Access Compliance Report

Public Rights-of-Way

(Curb Ramps)

Intersection ID: 53494	Main Street: PROVIDENCE_COUNTRY_CLUB_DR	Cross Street: HONEYMEADE CIR	Location: SE
ADA ID: C4BD1E0F1E29	Ramp Type: Directional	Initial Pass/Fail: Fail	Overall Compliance: No
Severity Score: 13.75			
Codes/Mitigation Info/Possible Solution		Field Measurements/Component Compliance

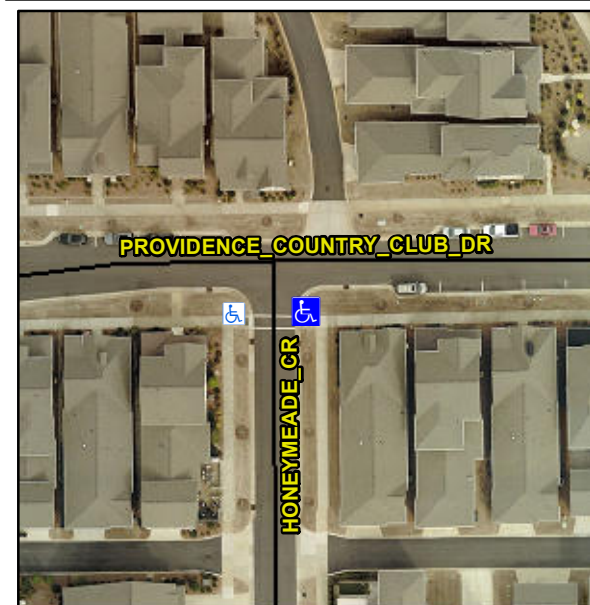
R304.2.2, R304.5.3

Compliance	Description	Data	Compliance	Description	Data
N/A	Ramp Length (in)	95.5	N/A	Grade Break?	N/A
Yes	Ramp Width (in)	70.0	N/A	Grade Break Slope (%)	0.0
No	Ramp Slope (%)	10.1	N/A	Grade Break XSlope (%)	0.0
No	Ramp XSlope (%)	2.6			
N/A	Flare Type LT	N/A	N/A	Flare Type RT	N/A
N/A	Flare Slope LT (%)	N/A	N/A	Flare Slope RT (%)	0.0
N/A	Flare Traversable LT?	N/A	N/A	Flare Traversable RT?	N/A
N/A	Landing Length (in)	0.0	N/A	DWS Provided?	N/A
N/A	Landing Width (in)	0.0	N/A	DWS Contrast?	N/A
N/A	Landing Slope (%)	0.0	N/A	DWS Length (in)	N/A
N/A	Landing X Slope (%)	0.0	N/A	DWS Full Width?	N/A
N/A	Landing Curb? (Y/N)	N/A	N/A	DWS Offset LT (in)	N/A
N/A	Shared Landing?	N/A	N/A	DWS Offset RT (in)	N/A
N/A	Gutter Ponding?	0.0	N/A	Gutter Slope (%)	N/A
N/A	Gutter Lip Ht (in)	0.0	N/A	Gutter X Slope (%)	N/A
N/A	Painted X Walk1?	No		Road Slope (%)	1.9
	X Walk 1 Direction	To W		Road X Slope (%)	2.5
	X Walk 1 Width (in)	N/A		Clear Space?	N/A

X Walk 1 Slope (%)	1.9	N/A	Clear Space to XWalk (in)	N/A
	X Walk 1 X Slope (%)	2.5	N/A	Storm Grate/Utility Hazard?	N/A
N/A	Ramp inside XWalk1?	N/A		Storm Grate/Utility Type	
N/A	Any Obstructions?	N/A			N/A
	Obstruction Type		Yes	Surface Condition? (G/P)	Good
			N/A	Curb Slope (%)	5.9

Remove & Replace Entire Ramp.
